### RESPONSE TO OFFICE ACTION REGARDING AMENDED CLAIMS overcoming 102 and 103 rejections for application 10,679,075

### **Appendix of patent claim reasoning for Application: 10,679,075**

Energy Generating Shelter System and Method  
Steven Durham  
Atty Docket:

Admitted Dec 28, 2007  
Reply to Office Action  
(Application) 10,679,075

FIG. 10

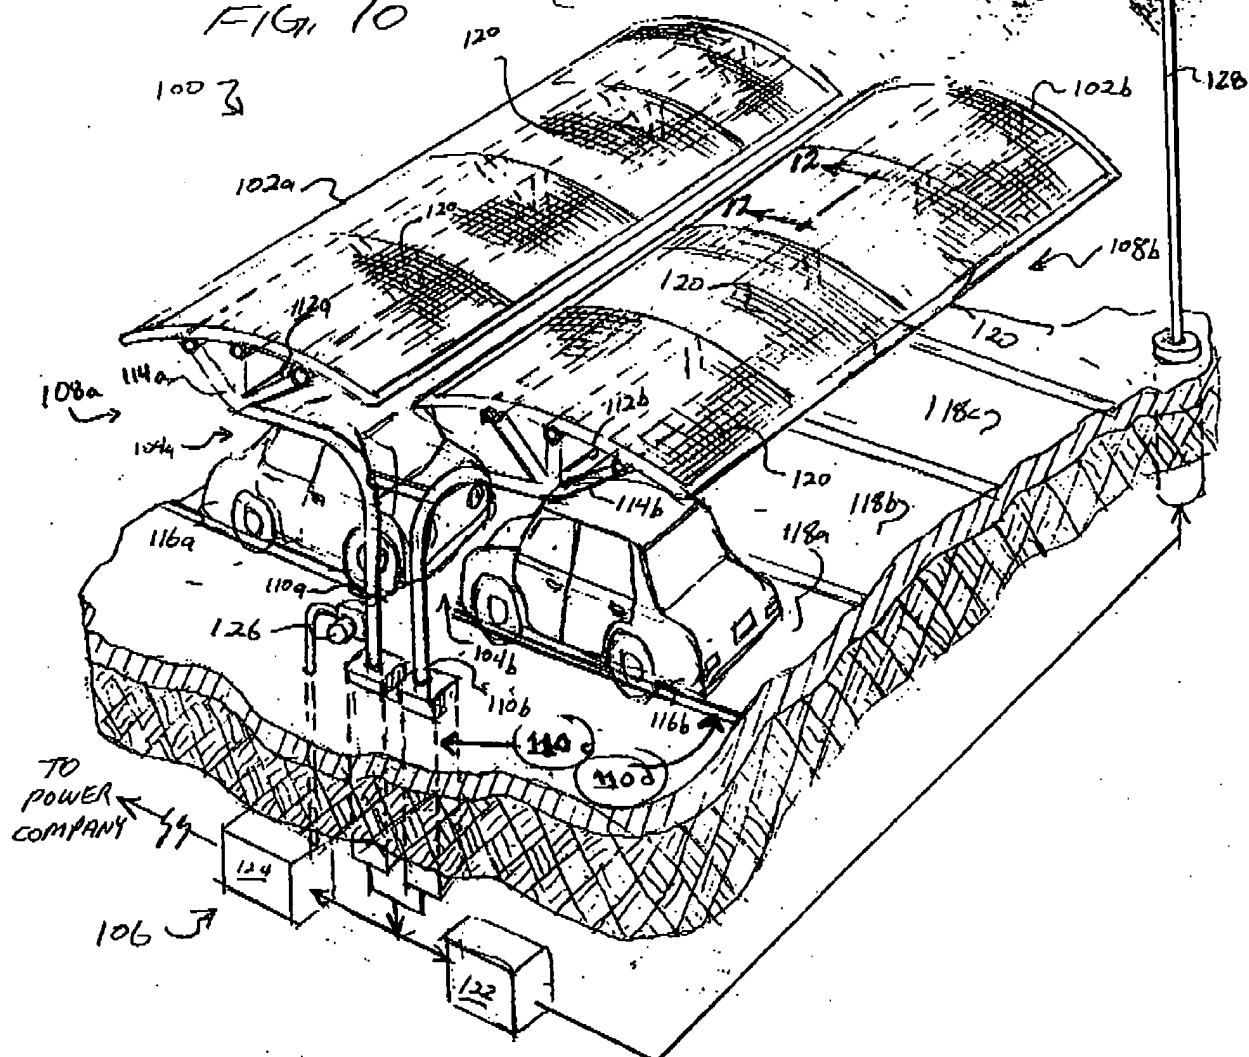
The attached sheet and drawings includes changes to Figure 10. This sheet which includes Figure 10, replaces the original sheet. In Figure 10, now indicates where the vertical support mounting foundation and placement lies 110 c (indirect mounting to foundation away from parking space) and 110d, (parking area demarcation zone) and 110e (parking stripe indicating laterally spaced area) .
